Dekko Designs Ltd. Dekko Washing Ltd

Purba Naroshinapur, Ashulia, Savar, Dhaka
(23.92663N, 90.30390E)

18 March 2014

Observations

Typical Floor Plan

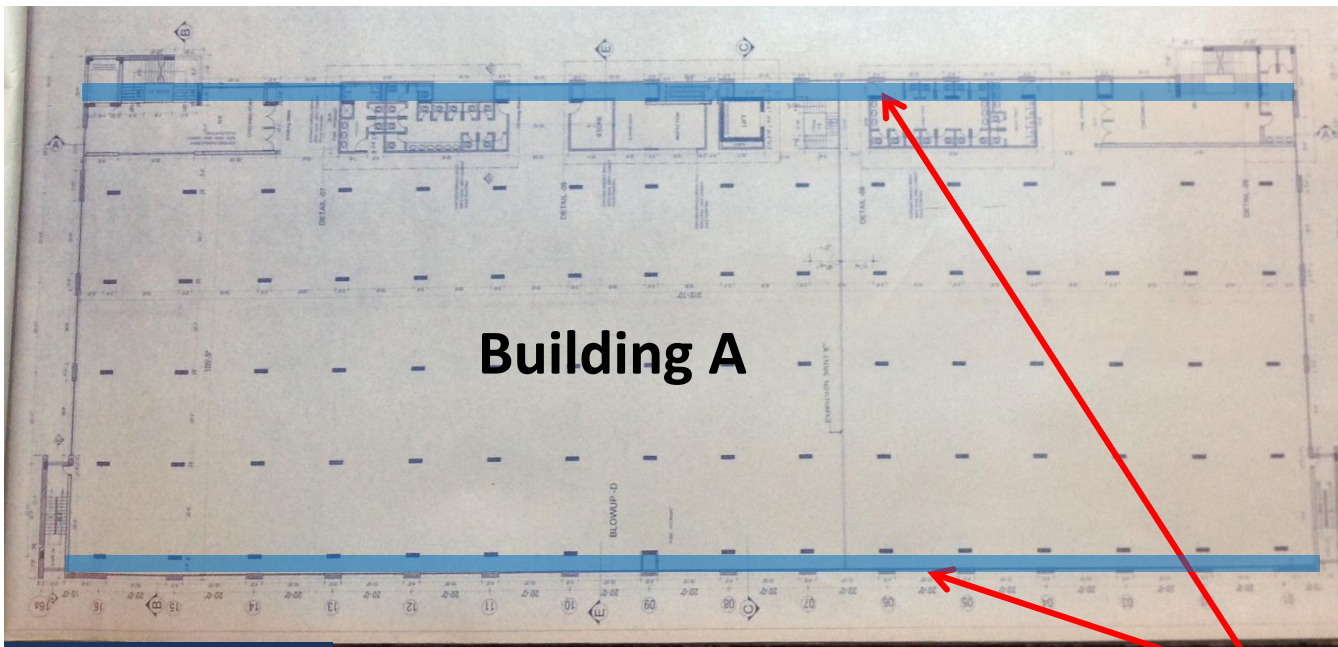
Design check required for the water tanks at present roof level of Building A and the storage area on the mezzanine floor to confirm floor load capacity

- 10 no. plastic water tanks located on roof slab.
- Building Engineer to check that the slab and beams have been adequately designed to carry loads due to plastic water tanks and plinth.

- Building Engineer to prepare controlled loading plans for all floors which will designate where storage can be placed.

- Locations of loading noted to be surveyed and capacity of floor structure to be assessed by the Building Engineer to confirm that the floor slab is designed to carry these loads.
- Produce and actively manage a loading plan for all floor plates within the factory giving consideration to floor capacity including punching shear in flat slabs and column capacity.

Typical Floor Plan

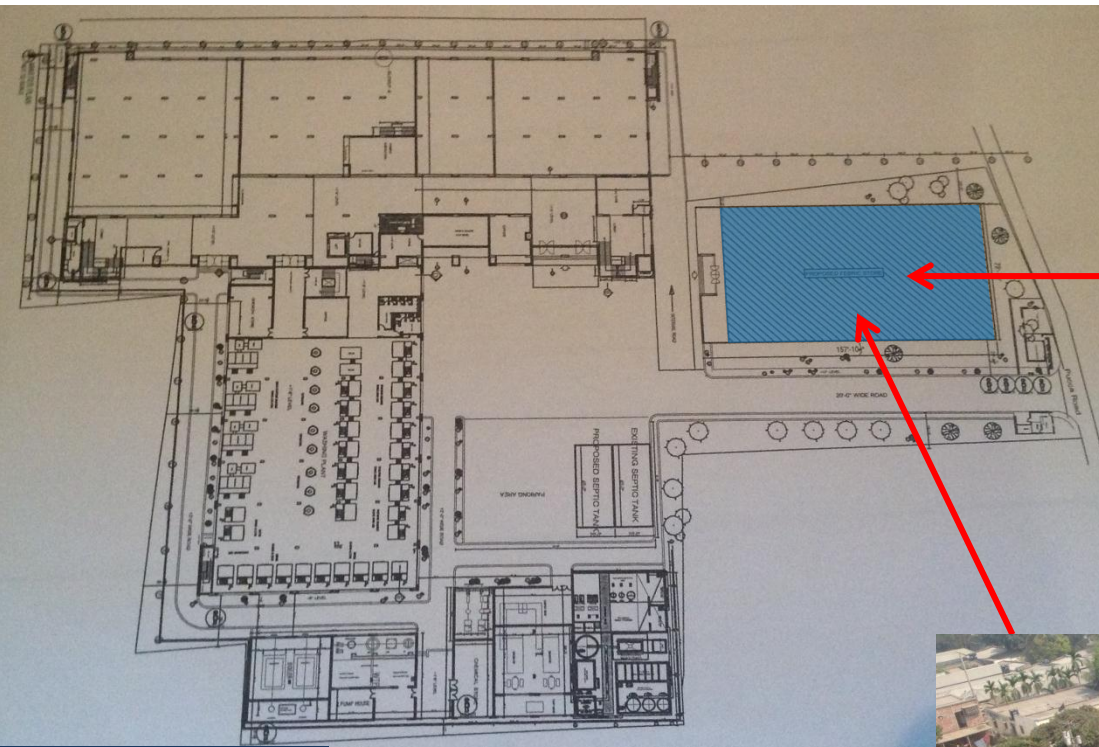
**Design check required for the east and west
floor cantilevers at the suspended floor
levels of Building A to confirm their load
capacity to support floor and façade
loading**

1.5m (avg) floor slab cantilever (no downstand beams) on west and east side from 1st floor to 4th floor

Building Engineer to check that the slab has been adequately designed to carry loading due to façade and floor loads

- Building Engineer to confirm the capacity of the slab to support the combination of the floor loading and the façade loading.

Site Plan

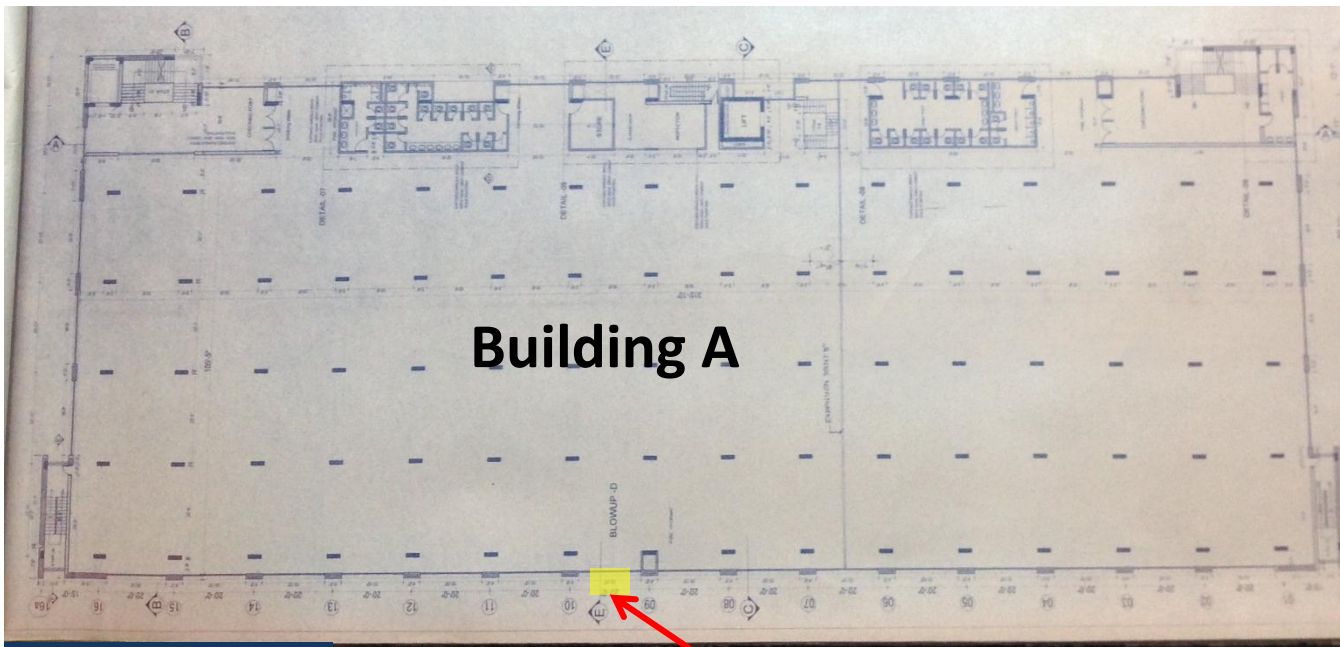
Design check required for the single storey storage building (Building E) to confirm its adequacy to support wind loading

Additional steel storage building constructed on site as shown.

Engineer to check design of steel structure to resist high wind and lateral loads and completeness of connections on site.

- Steel structure to storage area should be reviewed by the Building Engineer for wind loading and bracing added where required.

Roof Plan

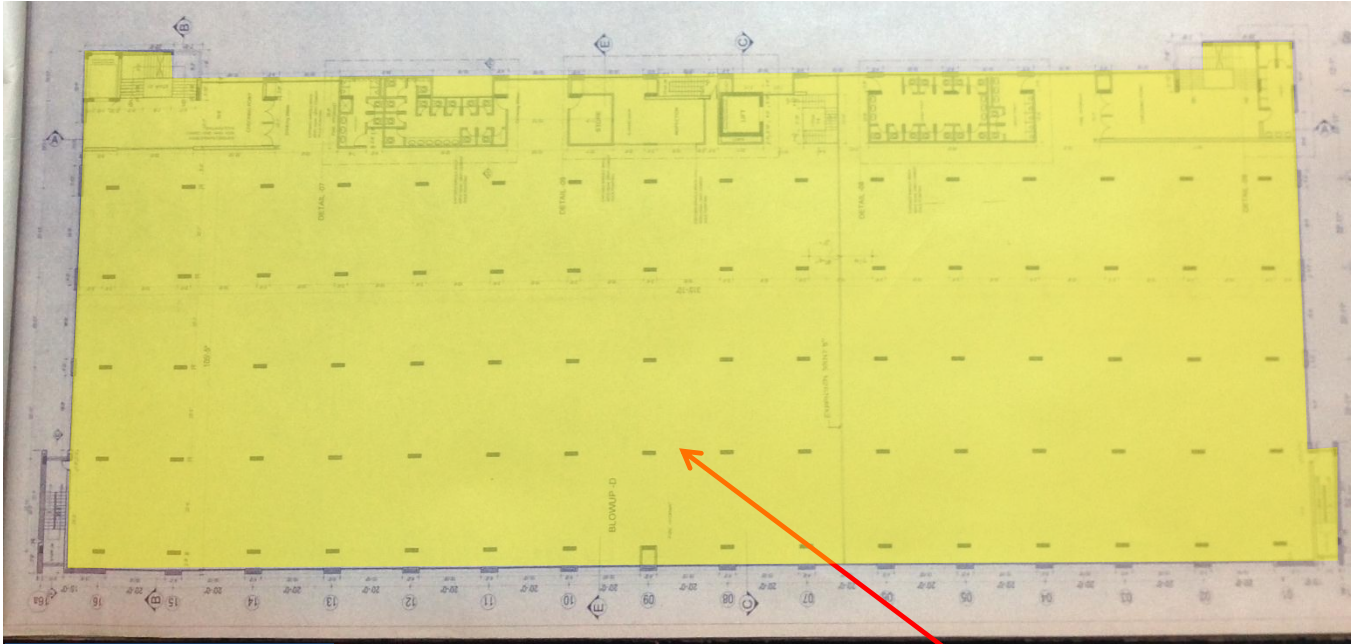
Design check required for the vertical ladder on the west façade of Building A

External steel ladder – Design check required to assess structure and load path for full ladder loading.

- Building Engineer to do a design check on the ladder, and the need for handrails should also be reviewed

Section

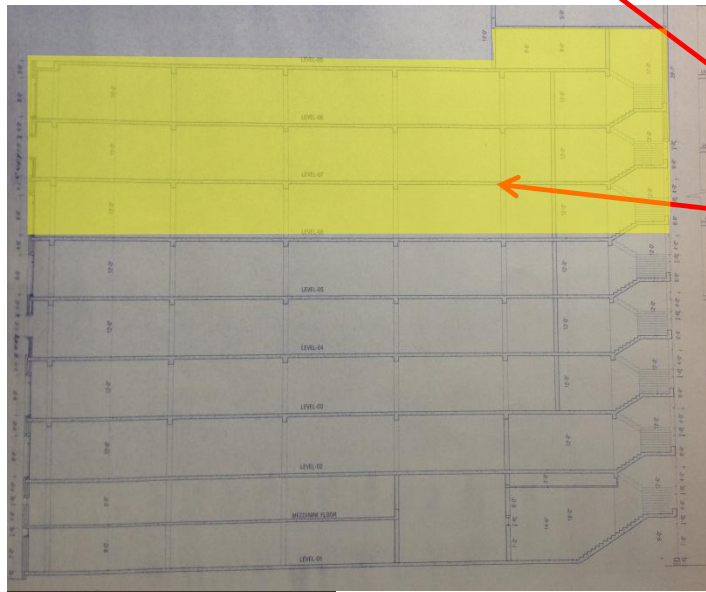
No further work is to be carried out on Building A without a full engineering submission and approval by Accord. If this work is intended to proceed, the requirements of the Detailed Engineering Assessment are to be followed.

**Additional storeys
should be reviewed by
the Building Engineer**

- If any additions to the building structure are proposed, the Building Engineer shall provide calculations showing the structural adequacy of all columns, foundations and lateral stability systems for such work, ensuring that the requirements of the Detailed Engineering assessment are met.
